DAWES LAKE TRACE SUBDIVISION

APPLICATION NUMBER 10 DATE April 15, 2004

REQUEST Subdivision

SUBDIVISION PLAN

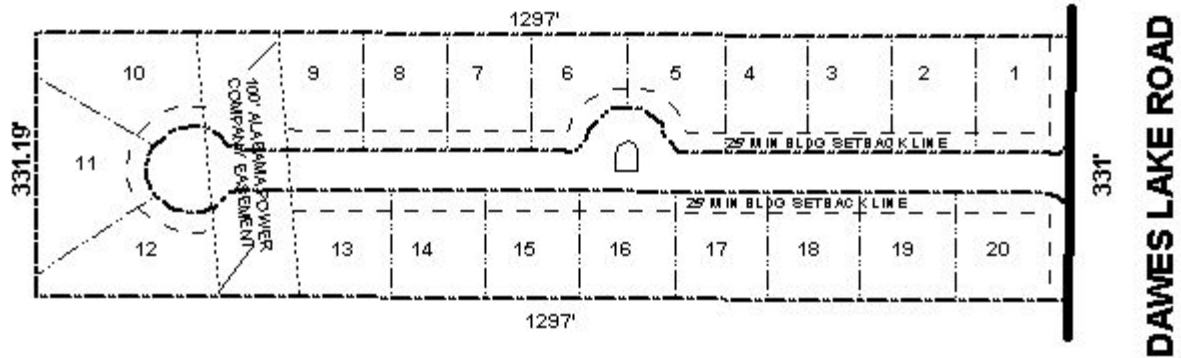
As proposed, Lots 1 and 20 would have frontage along Dawes Lake Road and the new street; therefore, the placement of a note on the final plat stating the Lots 1 and 20 are denied direct access to Dawes Lake Road, should be required.

The Subdivision Regulations state that a closed end street shall not be longer than 600'. Section V.B.1 also states that street stubs shall be provided to large undeveloped tracts of land. As proposed, the closed end street is approximately 1,297' long; therefore, a street stub to the North, between Lots 4-7, should be required. It should be noted that the large parcel to the North is undeveloped and does not have enough road frontage to allow the construction of a road. A similar subdivision was approved South of this site (Vintage Woods Subdivision) in 1988. The difference between this application and Vintage Woods is that Vintage Woods was not adjacent to a large undeveloped tract of land.

It should be noted that the applicant is providing a traffic calming device. The traffic calming device is not labeled as common area and thus should be labeled as such. In addition, the placement of a note on the final plat stating that the common area is the responsibility of the property owners, should be required.

This site is located in the County, thus a note should be placed on the final plat stating that any lots which are developed commercially, and adjoin residentially developed property, must provide a buffer, in compliance with Section V.A.7. of the Subdivision Regulations.

With modifications, the plat meets the minimum requirements of the Subdivision Regulations and is recommended for Tentative Approval subject to the following condition: 1) the placement of a note on the final plat stating the Lots 1 and 20 are denied direct access to Dawes Lake Road; 2) the provision of a street stub to the North located between Lots 4-7; 3) location and design of the traffic calming device to be approved by County Engineering; 4) the traffic calming device be labeled as common area with a note placed on the plat stating that the maintenance of the common area is the responsibility of the property owners; and 5) the placement of a note on the final plat stating that if any property is developed commercially and adjoins residential property, a buffer in compliance with Section V.A.7. of the Subdivision Regulations, will be provided.
